GLOBAL SAFETY FIELD INVESTIGATIONS
DCS5860
URGENT - DISTRIBUTE IMMEDIATELY

Subject: A212336520 - Service Update
Front Left-Hand Strut to Body Not Secured

Models: 2021 Chevrolet Bolt EV

A212336520 Front Left-Hand Strut to Body Not Secured

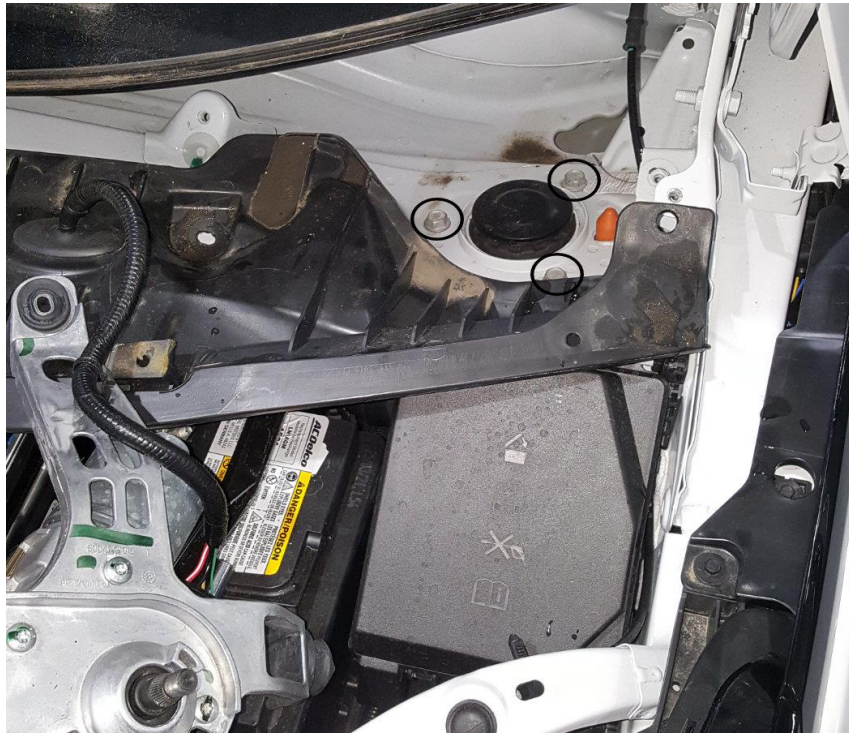
Condition	On certain 2021 model year Chevrolet Bolt EV vehicles, the front left-hand side front suspension strut to the body fasteners may not be torqued properly.
Correction	Dealers are to check the torque and replace the bolt if necessary.

2. Check torque on the left front strut bolts (circled) using a torque wrench. All bolts should be torqued to 16 Lb-ft (22N-m).
 - If any bolts are found to be loose, replace them, and then torque to 16 Lb-ft (22N-m).
3. Reinstall the Front Left Windshield Wiper System Module. Refer to *Windshield Wiper System Module Replacement* in SI.
